REVISED RESPONSE TO REQUEST FOR ADDITIONAL INFORMATION

APR1400 Design Certification

RAI No.: 227-8274
SRP Section: 03.08.04 – Other Seismic Category I Structures
Application Section: 03.08.04
Date of RAI Issue: 09/25/2015

Question No. 03.08.04-7

Figure 3.8A-40 Reinforcement Arrangement of the AB MSIV House Wall (Section 1)

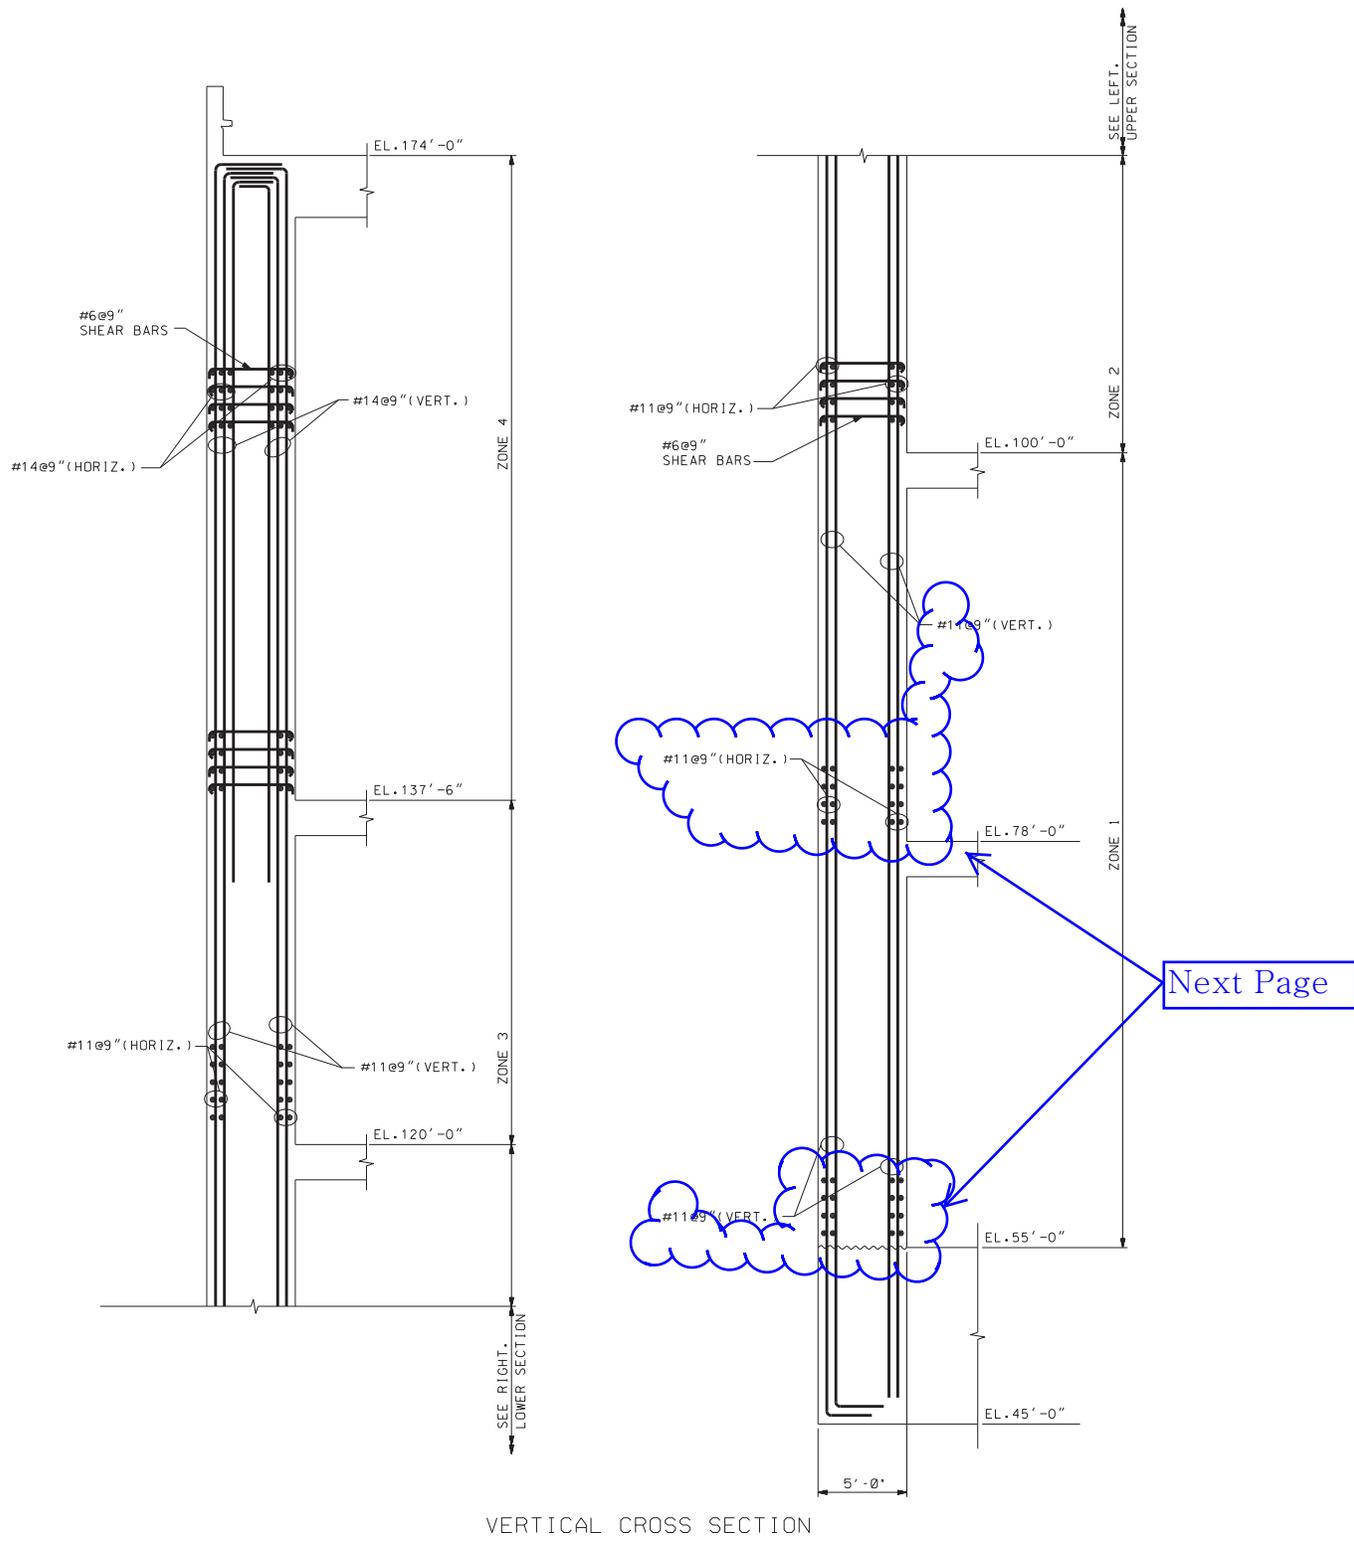
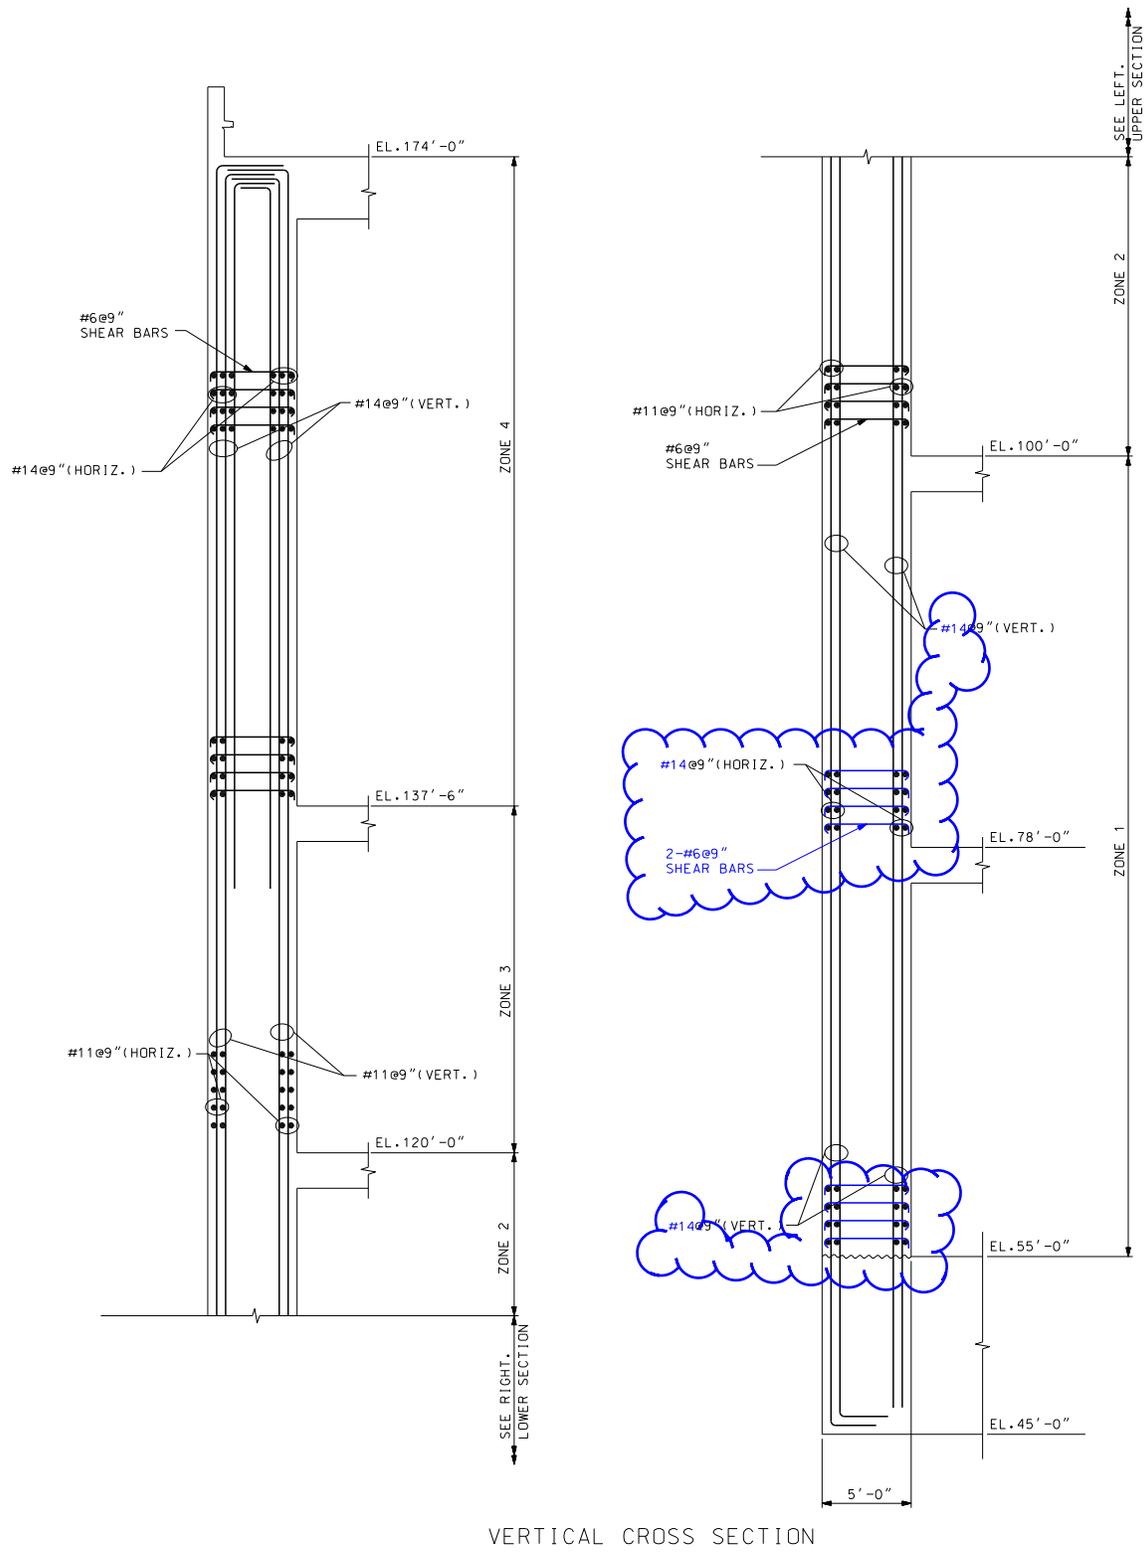
a) Applicant is requested to describe how all walls below grade were analyzed and designed for dynamic lateral earth pressures for all structures, and if the approach was consistent with that described in SRP 3.8.4 II.4.H. If not, provide the basis for using the alternative approach. In addition, for the calculation of the hydrodynamic effect of pure water, determined based on the hydrodynamic formula suggested by Matsuo and O'Hara, the formula used should be provided and the full reference designation for this, as well as any other references discussed in the DCD should be identified in the DCD.

Based on the revised analyses, the dynamic earth pressures determined from the SSI and SSSI analyses are the governing case. Therefore, the structural analysis of the Auxiliary Building was revised using the governing dynamic earth pressure obtained from the SSI and SSSI analyses. Based on the results of the revised structural analysis, the structural member forces of the exterior walls below grade level were determined, and the design of these exterior walls was evaluated again. Consequently, the increased dynamic earth pressure led to an increase in the amount of reinforcement steel required in the Auxiliary Building walls. Therefore, Tables 3.8A-28, 3.8A-29 and Figures 3.8A-40, 3.8A-41, 3.8A-43, 3.8A-44 will be revised as shown in Attachment 3 associated with this response.

DCD Tier 2 Subsections 3.8.4.3.4, 3.8.7, 3.8A.2.4.2, 3.8A.3.4.2 and Tables 3.8A-28, 3.8A-29 and Figures 3.8A-40, 3.8A-41, 3.8A-43, 3.8A-44 will be revised as indicated in the attached markup.
